TC-60/120

# Service Bulletin

Biamp Systems, Inc.

## GUIDES AND MODIFICATIONS FOR THE TC/60 & TC/120

REV.	DATE	BY
A	10/19/78	Biamp TC 60
B		Drawing JOHN PAYNE
C		Design DALE SLIGER
D		
E		
F		
G		
H

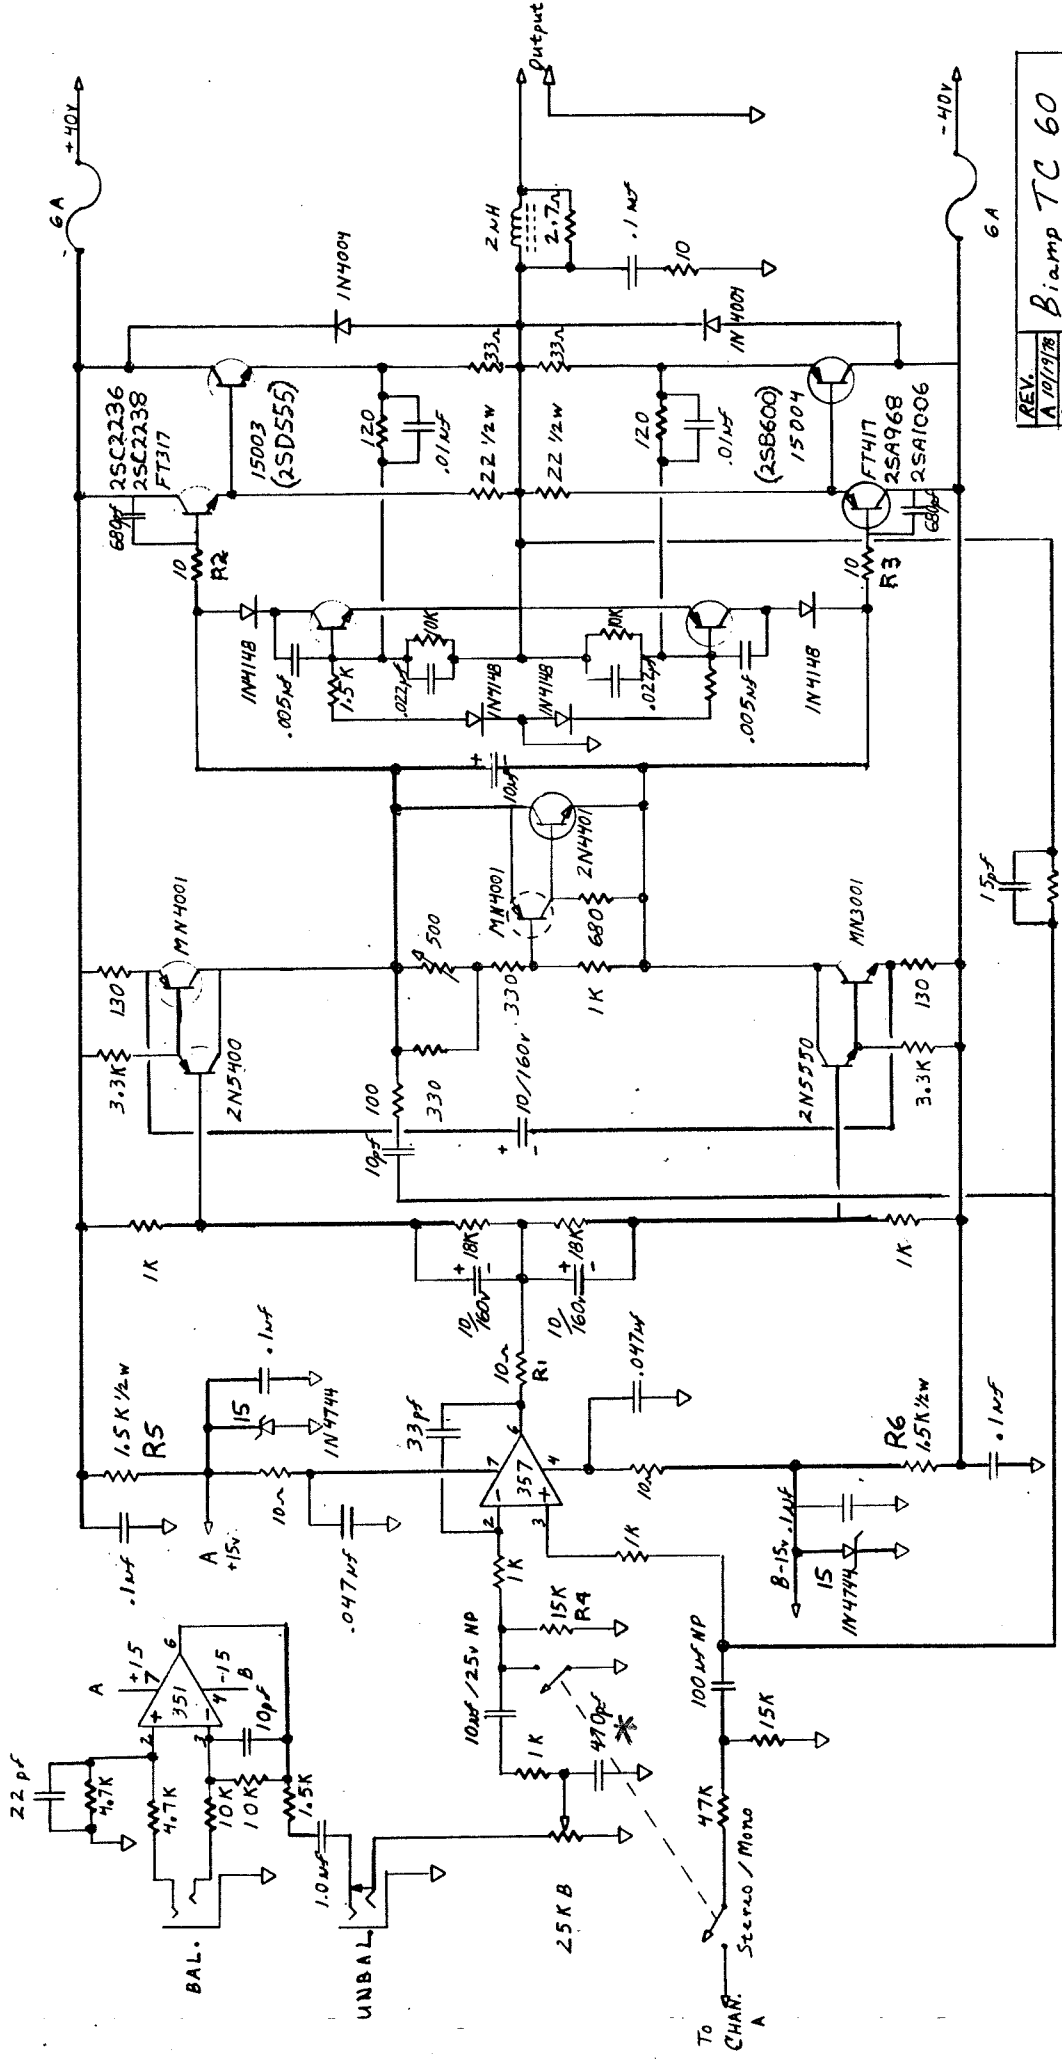
Resistors R5 and R6 are 1500 ohm,  $\frac{1}{2}$  watt components. These have proven to be under-rated and should be replaced with 1 watt resistors any time these units are serviced.

The trouble symptom for failure of either of these resistors is D. C. voltage on the speaker terminals.

The LF357 input IC was changed during production to a 5534 IC. This change requires that R4 also be replaced with 47,000 ohm resistor.

D.C. voltage on the speaker terminals can originate anywhere within the circuit. Isolation of stages is possible by lifting on end of both R2 and R3. When these resistors are lifted the D.C. voltage across the speaker post terminals will be about 0.5 volt D.C., no load. If this voltage is correct the driver and output transistors are OK. Reconnect ~~R2~~ and ~~R3~~.

To separate the input IC from the pre-driver circuit requires a 25K ohm potentiometer with 3 wires and miniature clips to allow simulation of the IC operation.

1. Lift the IC end of R1 and attach the wire from the pot wiper to the loose end of R1.
2. Attach the two remaining wires to the plus and minus 15 v Zener regulators
3. Connect a DMM to the speaker posts (no load) and set the range for 100 volts or more.
4. Rotate the 25K ohm pot from one stop to the other. If the pre-drivers are operating properly the D.C. voltage across the speaker post will switch polarity and can be "0" centered with careful adjustment. If these results are obtained the trouble is the input IC or the ground reference resistors (TC/120). If the above results are not attainable the problem lies in the pre-driver stages. Measure the emitter-base junctions for 0.6 V to indicate proper operation.

When properly operating the D.C. offset voltage across the speaker posts should be less than 10mV D.C. Bias should be set at 1.5-2.0mV across the 0.33 ohm emitter resistors.

NOTE: IF OSCILLATION OCCURS AFTER TWEET-OFF  
 47uF CPP MARKED \* IS MISSING

Biamp TC 120  
 Drawing JOHN PAYNE  
 Design DALE SLIGER  
 Beaverton, Ore.

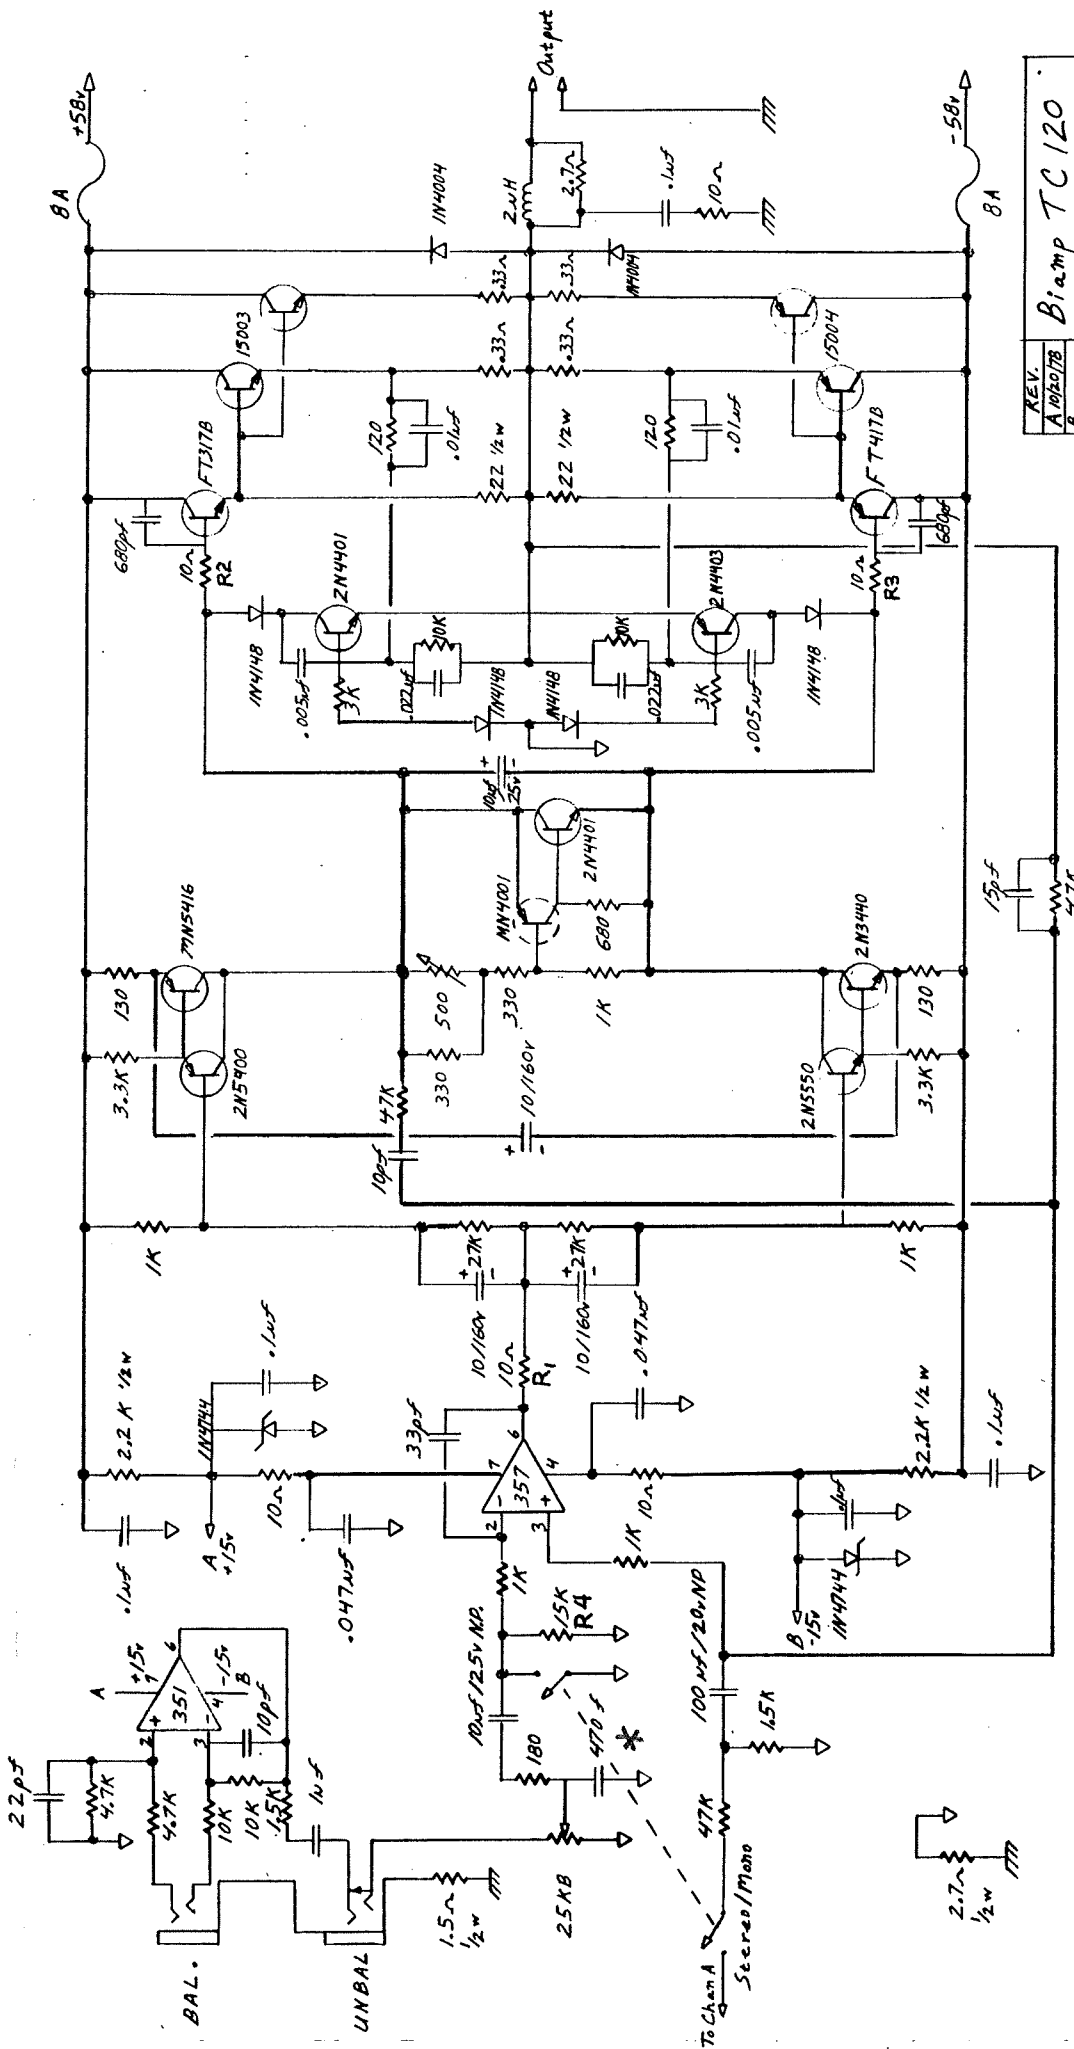
Note: If oscillation occurs AFTER Turn-off Then the 470pF capacitor \* is missing
